Reviewed 12/27/06

**Storm Water Management/Drainage Report
For
River Rock Subdivision**

Date: November 1, 2006

TITLE: **POST DEVELOPMENT DRAINAGE PLAN**

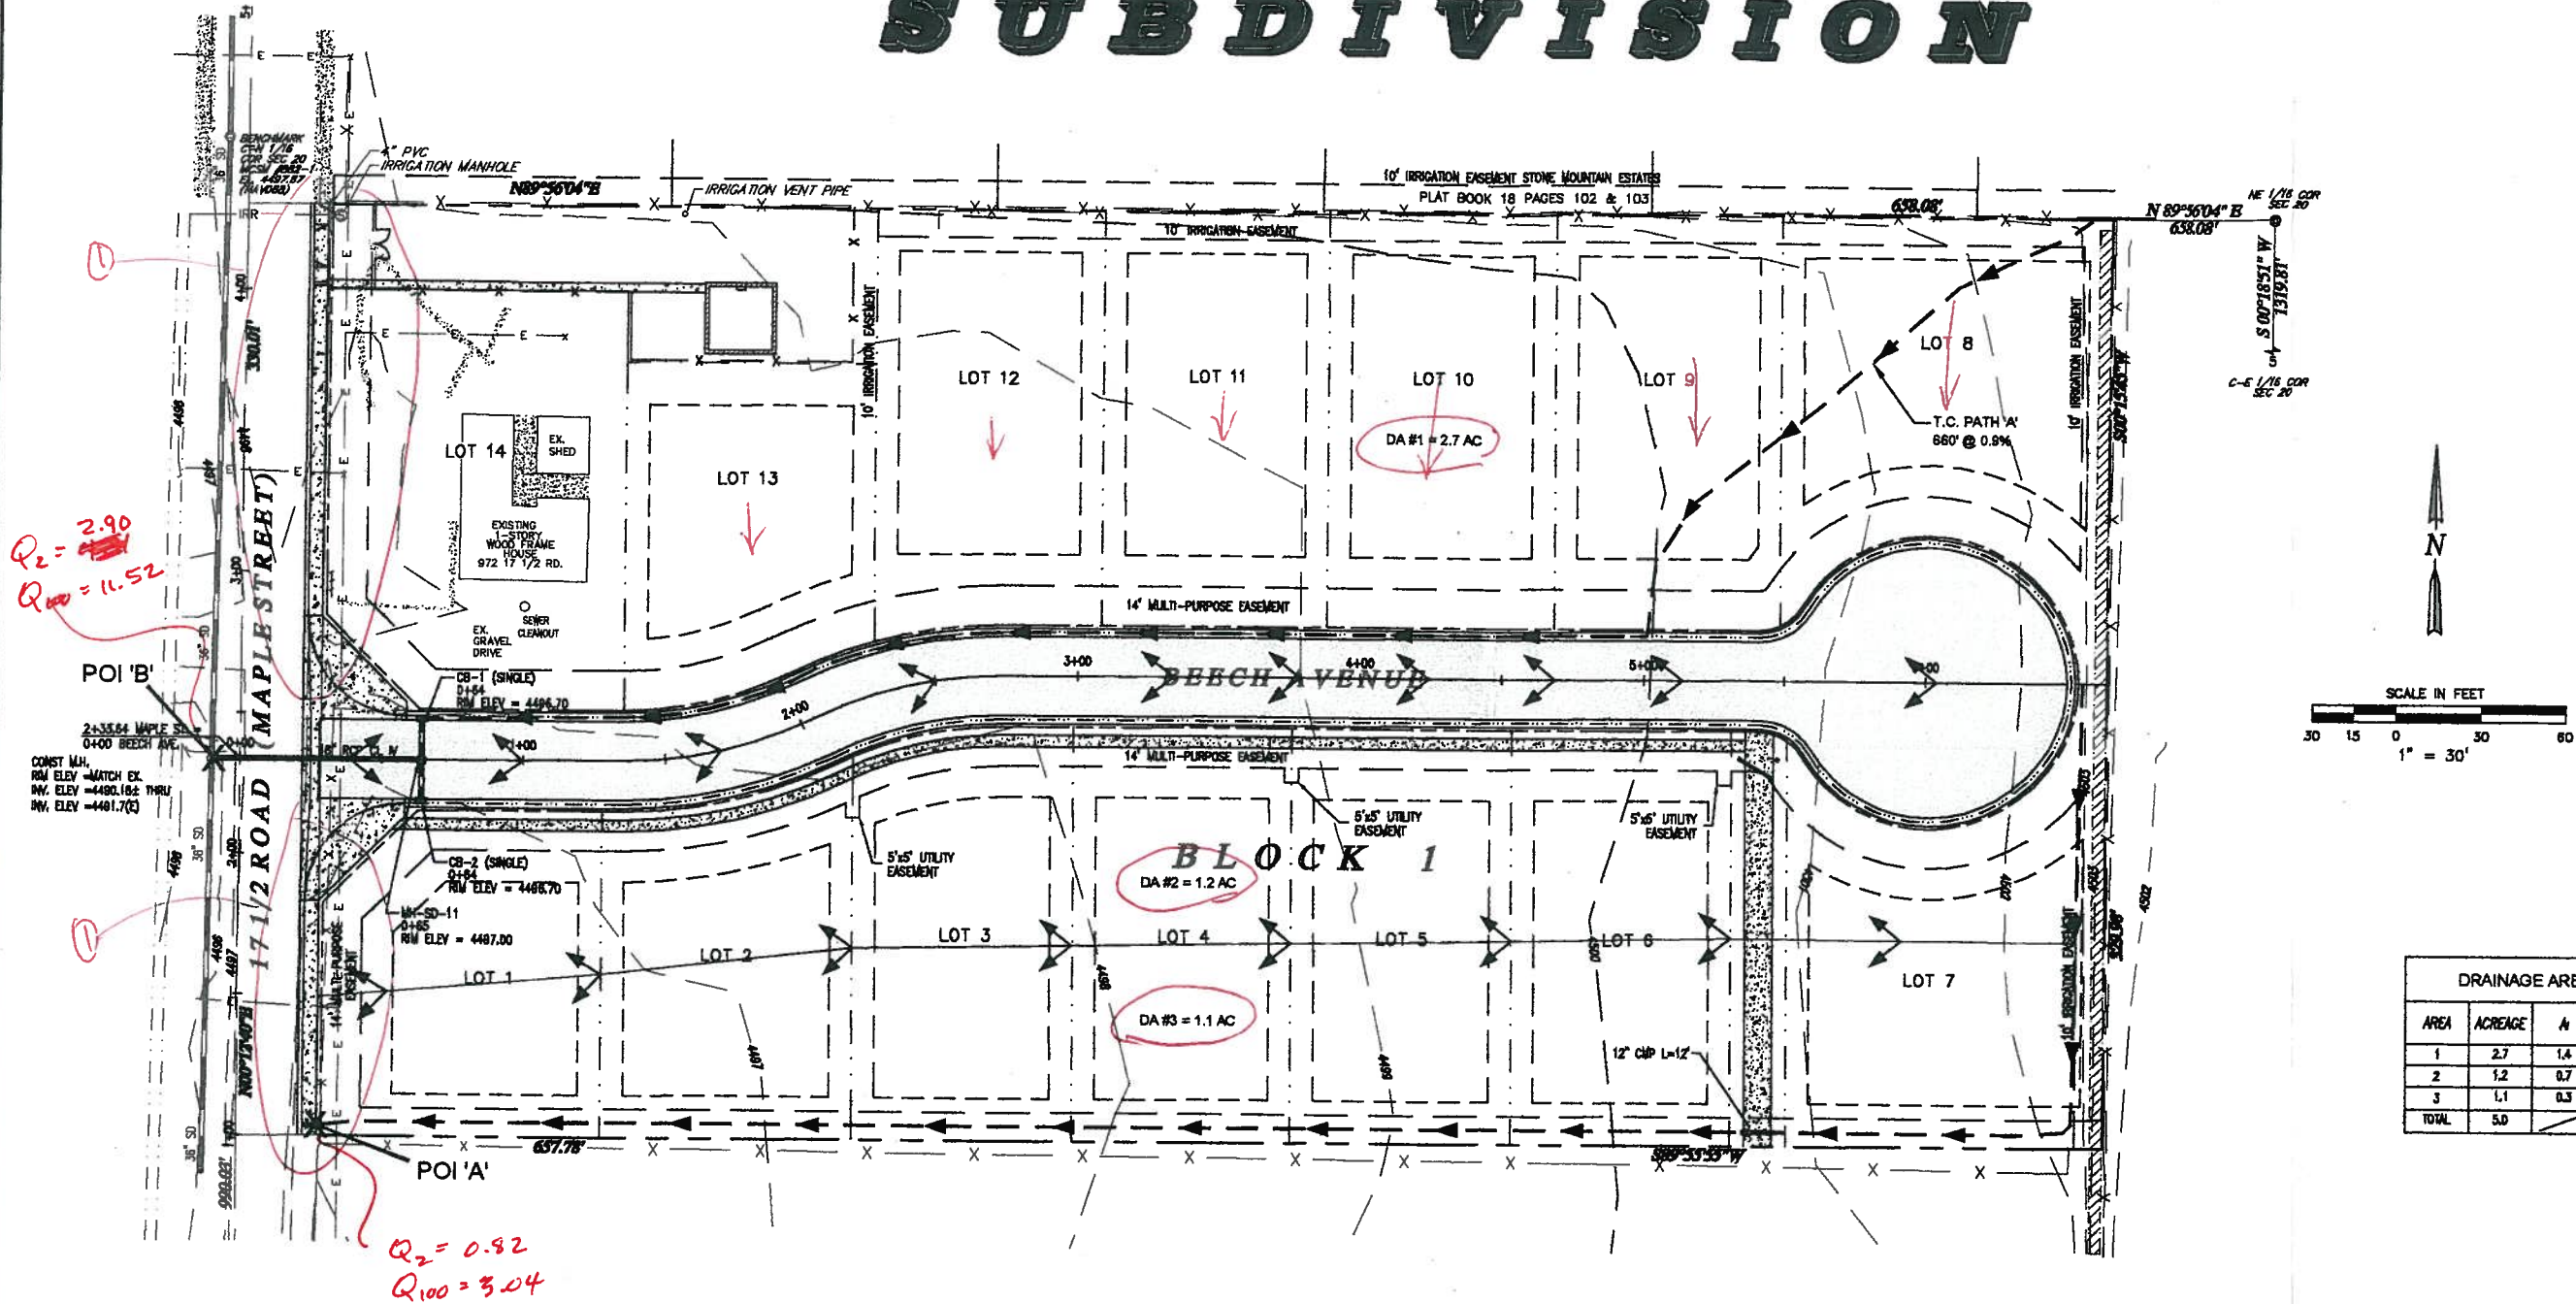
① Need to address these sub-basins because they affect drain inlet capacities and affect off-site impacts.
